**Re: 49 CFR Part 573; Recall of Mercedes-Benz SLR McLaren (199) Alternator**

**Re: Recall Campaign 2006060003 – Replace Alternator and CL Control Module;  
Install Heat Shield on New Alternator, Model 199 SLR McLaren  
Model Year 2005 – 2006**

SUBJECT: **MODEL 199, MODEL YEAR 2005-2006  
REPLACE ALTERNATOR AND CL CONTROL MODULE; INSTALL HEAT SHIELD ON  
NEW ALTERNATOR**

Figure 1

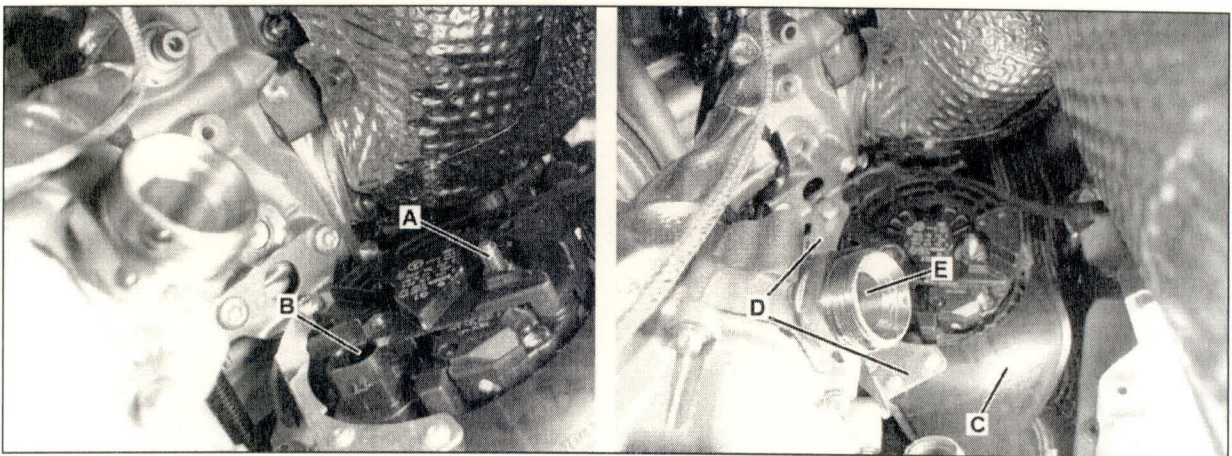
- Remove B+ connector cap and nut (A, Figure 1).
- Remove connector coupling from alternator (B)

- Remove air duct (C) and bracket (D) from alternator.
- Remove front alternator mounting bolts.
- Remove oil return line adapter (E) from upper oil pan.

- Connect line B+ to alternator (A, Figure 1); torque bolt to 15 Nm.

5. Reassemble in reverse order.
  - Torque oil return line adapter (E, Figure 1) at upper oil pan to 60 Nm.  
**CAUTION!**
    - **Exercise extreme care when reinstalling the oil return line adapter to prevent possible damage to the threading.**
  - Note:**
    - **No new sealant is required for reinstallation of the adapter.**
  - Use Loctite 242 when reinstalling oil lines into filter housing adapters.
  - Refer to the Additional Torque Settings on page 6 for correct torque settings during reassembly.
6. Install new CL control module and air brake (one unit); refer to WIS document AR54.21-P-1500SLR.
7. Connect ground line of battery; refer to WIS document AR54.10-P-0003SLR.
8. Run engine and check for oil leaks.

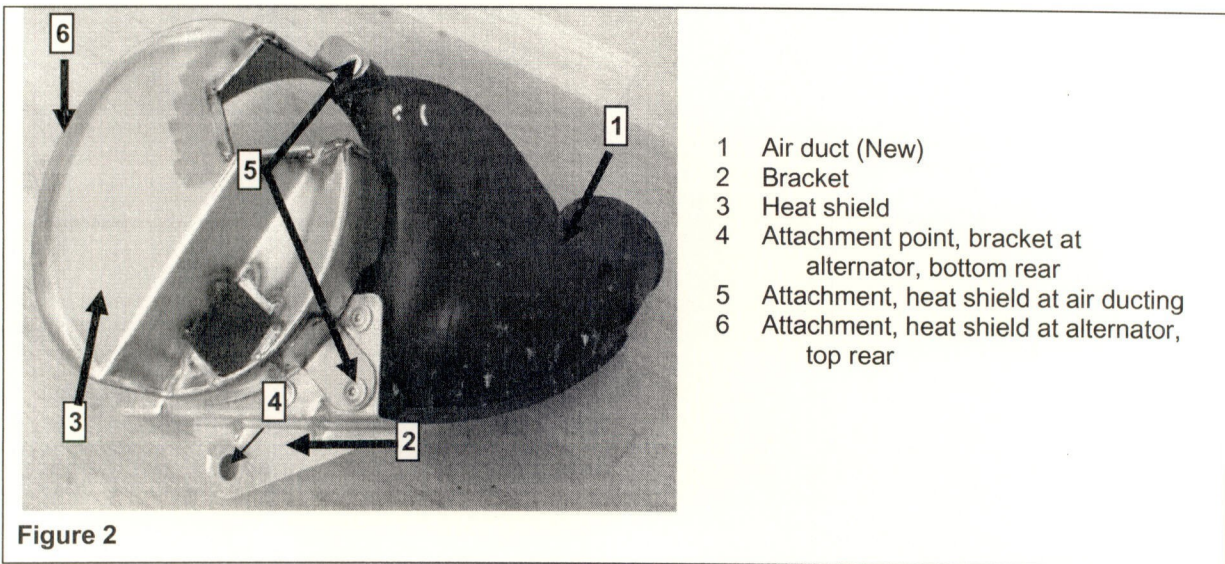
- 1 Air duct (New)
- 2 Bracket
- 3 Heat shield
- 4 Attachment point, bracket at alternator, bottom rear
- 5 Attachment, heat shield at air ducting
- 6 Attachment, heat shield at alternator, top rear

4. Install new alternator and new air duct (1, Figure 2).

**Reuse the existing bracket (2) between the heat shield and alternator. Do not reuse the existing air duct.**

- Install new alternator and tighten front mounting bolts. Torque bolts to 30 Nm.
- Fasten new air duct (1) with bracket (2) for heat shield (3) to lower rear mounting for alternator.

- Affix heat shield to top rear (6) of alternator.
- Fasten heat shield to air duct (5).

**Reuse one existing bracket screw and use the one new screw provided to fasten the heat shield to the air ducting.**
